*NHS-0000-00(691)*  
*I-16 Median Rest Area*  
*P.I. No. 0000691*  
Candler County, Georgia

## Value Engineering Study Report

re: Project Number NHS-0000-00(691), P.I. No. 0000691  
I-16 Median Rest Area, Candler County, Georgia  
Value Engineering Study Report—Concept Development Stage

# SKETCHES

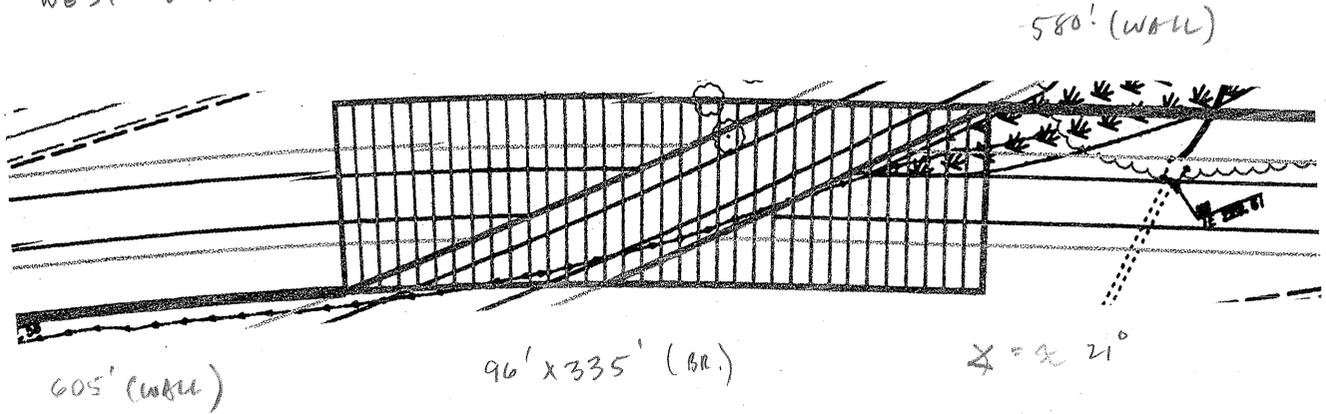
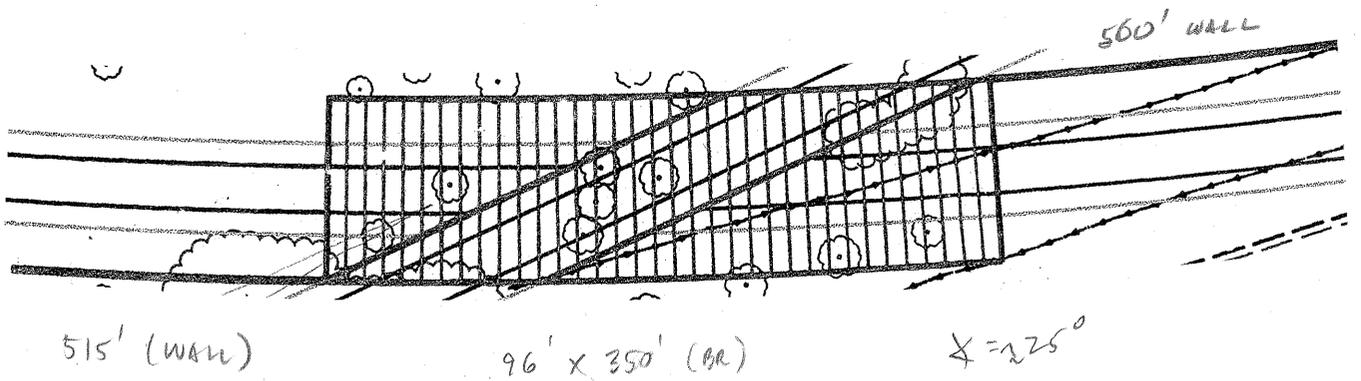
DESCRIPTION: **REDUCE SPAN OF PROPOSED BRIDGES TO  
 ACCOMMODATE TWO LANES ONLY**

The current design proposes the construction of two new bridges that will “scissor” (i.e., flip) the mainline eastbound and westbound directions to allow right-hand access to and from the rest area. Although the proposed bridges are shown as two-lane facilities, they have been sized to three lanes to accommodate future expansion.

Reduce the span of the proposed bridges to accommodate two lanes only.

The design documents provided indicate the Annual Average Daily Traffic (AADT) for this corridor of I-16 in the design year of 2027 will only be 28,000 vehicles. This relatively low traffic count does not warrant providing for potential future expansion of the facility.

THE COST ESTIMATE OF THE BRIDGES AND MSE WALLS TOGETHER IS \$5,129,055. A UNIT COST OF \$60/SF FALLS WITHIN THE COST ESTIMATE. AVE. WALL HT. @ \$35/SF IS 15.23'

REDUCING THE SPAN LENGTH BY ONE LANE (12')

$$\text{AREA} = 12' (335' + 350') = 8,220 \text{ SF.}$$

$$\text{WALL LENGTH} = \frac{12'}{\tan 21^\circ} \times 2 + \frac{12'}{\tan 25^\circ} \times 2 = 114'$$

PROJECT: NHS-0000-00(691), P.I. No. 0000691, I-16 MEDIAN REST AREA  
Candler County, Georgia Department of Transportation  
Conceptual Design Stage

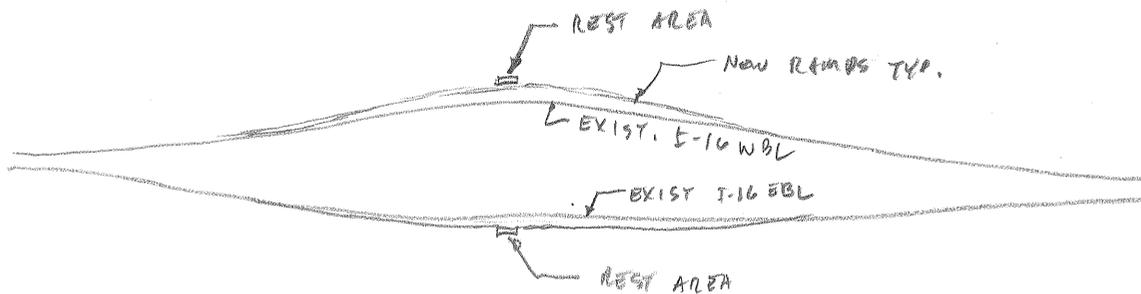
DESCRIPTION: **PROVIDE TWO REST AREA BUILDINGS OUTSIDE THE**  
**MEDIAN**

Maintain the I-16 mainline alignment and provide new deceleration/acceleration ramps to accommodate right-lane ingress/egress outside the median. Restroom facilities can be dedicated to each traffic direction.

In order to accommodate right-lane ingress/egress, new rest areas can be constructed outside the mainline where the least impact to the environment can be realized. This alternative would intrinsically have the least impact on the current mainline alignment and drive expectations. The emergency parking lot access should be located along the westbound lanes of I-16. Although use of the existing median lake for scenic enhancements is lost, architectural embellishments of the two restroom buildings can still be achieved.

ALTERNATIVE NO.:  
18-A

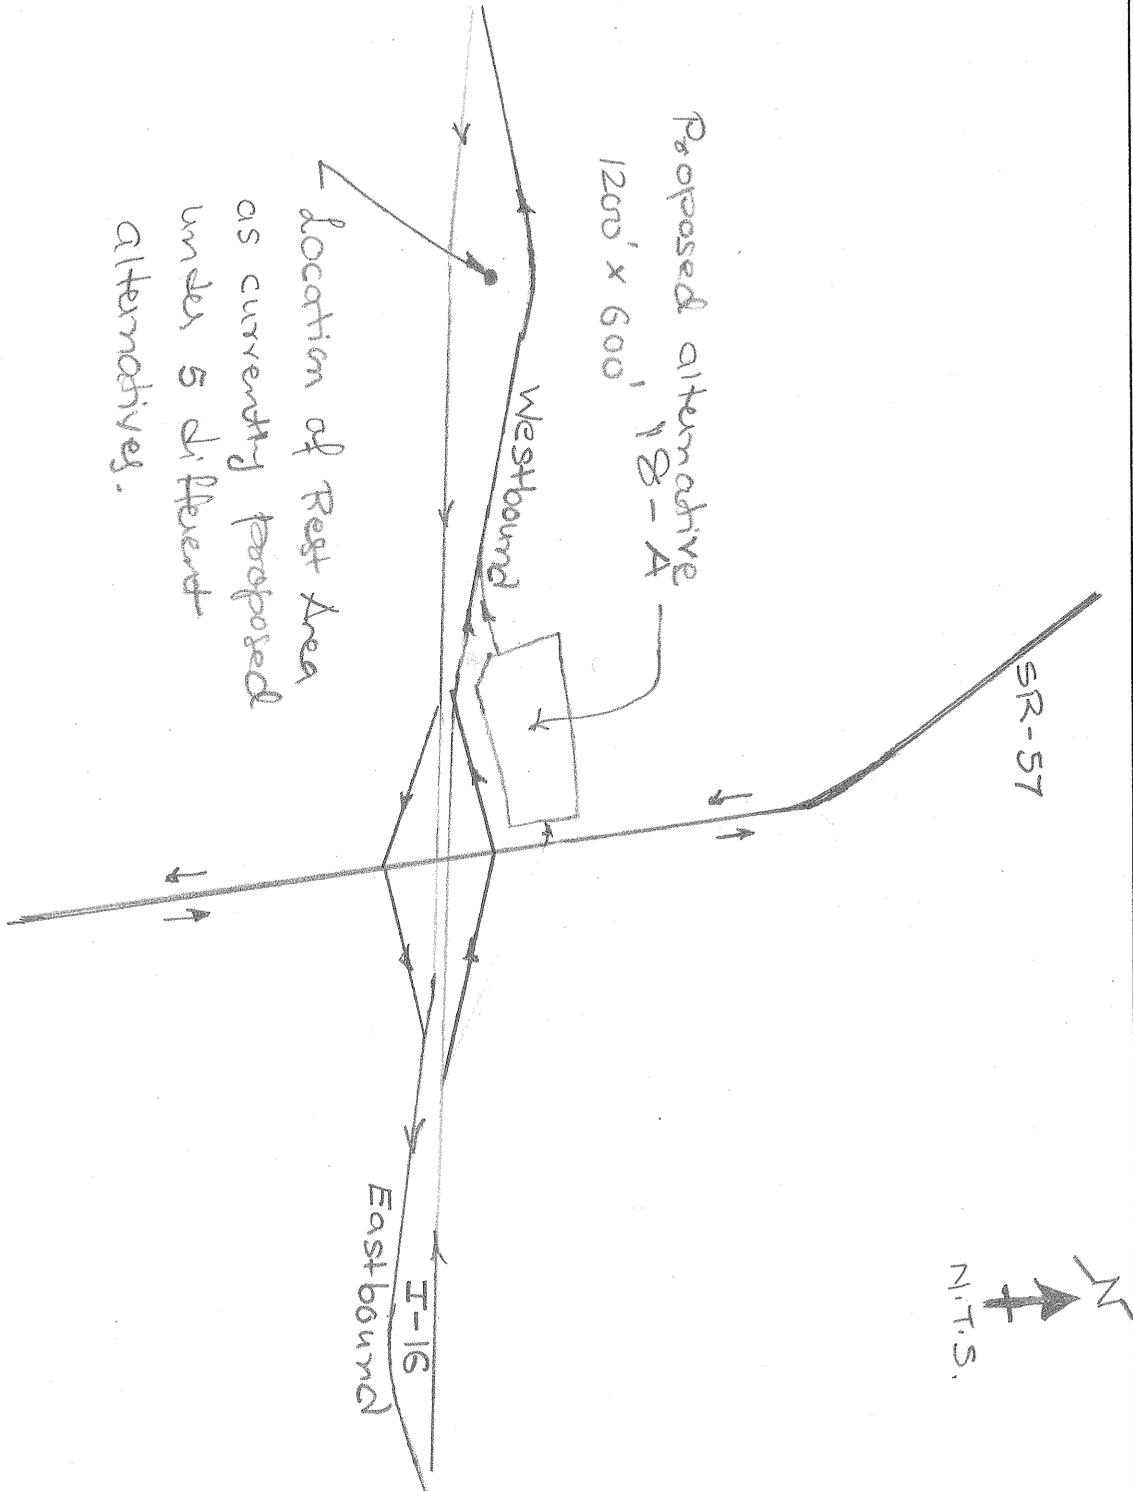
DESCRIPTION: **DEVELOP ONE REST AREA AT THE I-16/SR 57 INTERCHANGE**

PROJECT: NHS-0000-00(691), P.I. No. 0000691, I-16 MEDIAN REST AREA  
 Candler County, Georgia Department of Transportation  
 Conceptual Design Stage

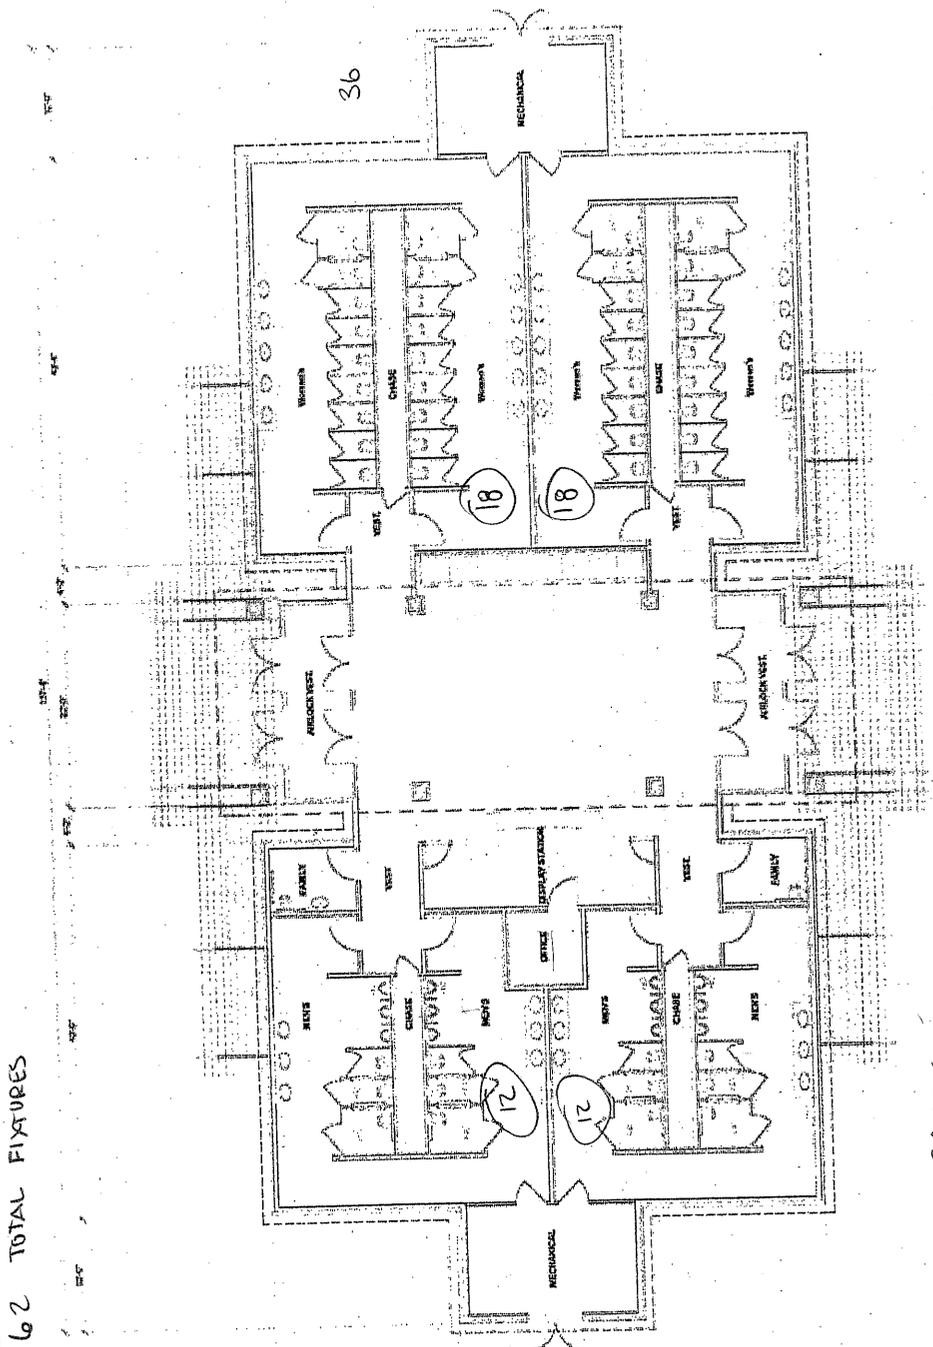
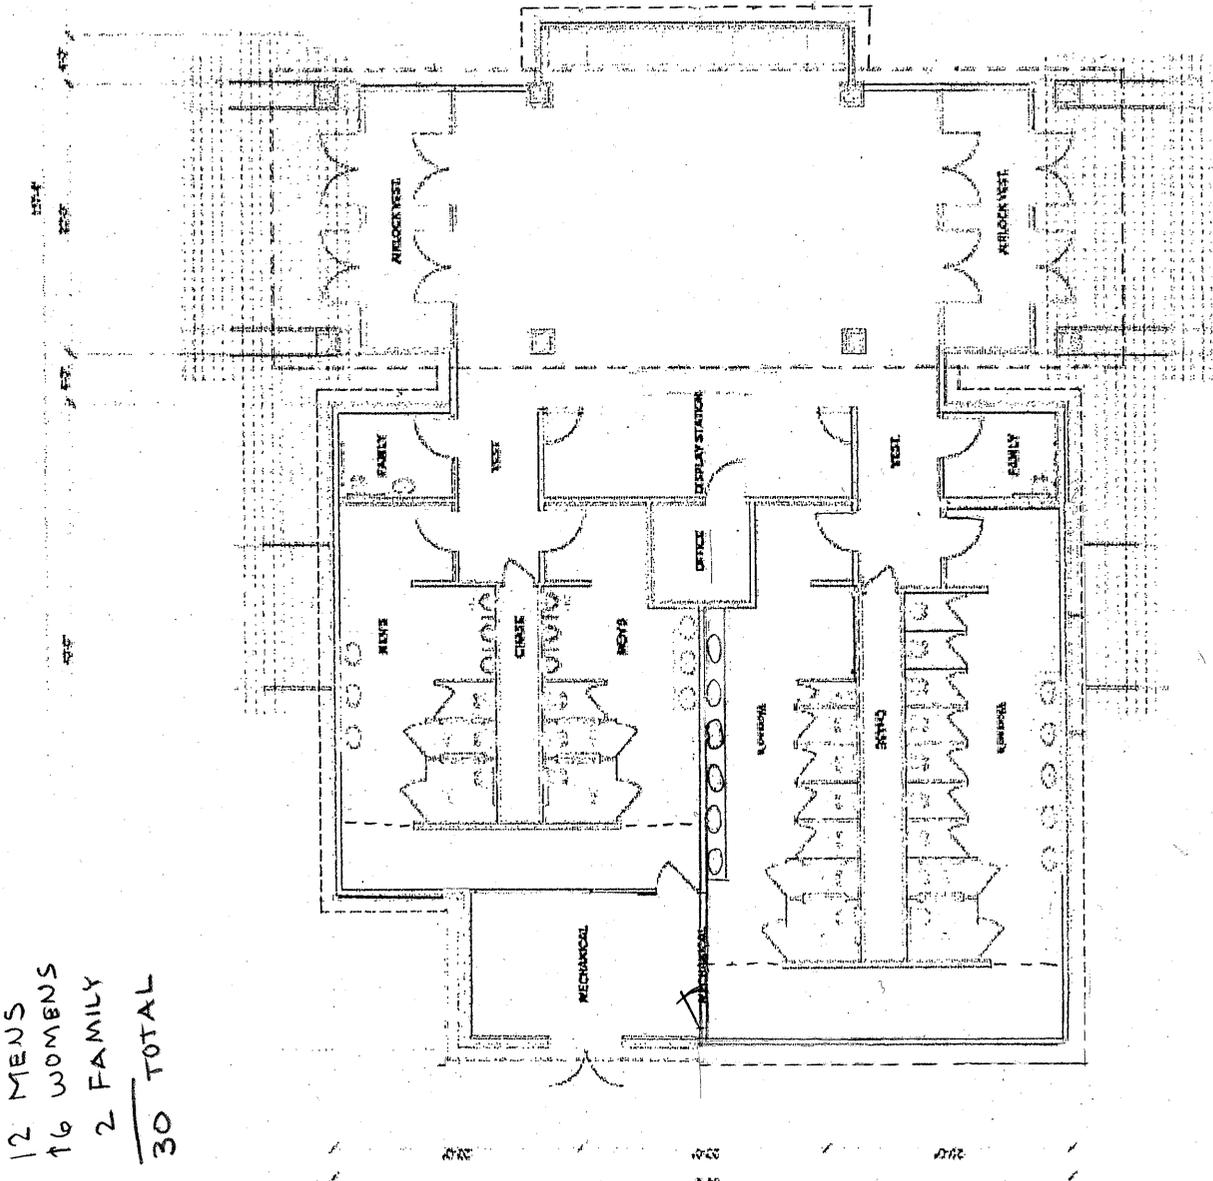
The normal traffic counts do not justify the number of fixtures planned. The design team indicated that during emergencies and evacuations, temporary toilet facilities would be provided at the overflow/emergency parking lot. Additional temporary toilets could be used if needed.

The reduced number of plumbing fixtures helps minimize the use and potential waste of potable water.
